Access Compliance Report Public Rights-of-Way (Pedestrian Signals)

Main Street: CRAWFORD_CANYON_RD Cross Street: CHAPMAN_AVE Location: SE

ADA ID: SGRK211007171405 Signal Type: One Push Button-Non APS Overall Compliance: No Severity Scores: BTN 1: 35 BTN 2: N/A No BTN: N/A

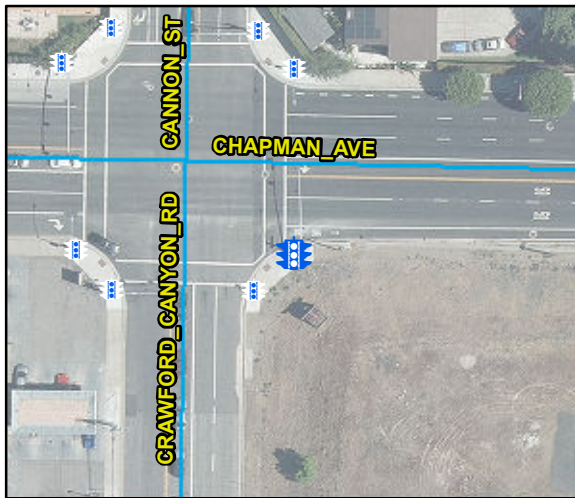
Possible Solutions: Replace Signal Push Button With APS Button. Remove and Replace Clear Space.
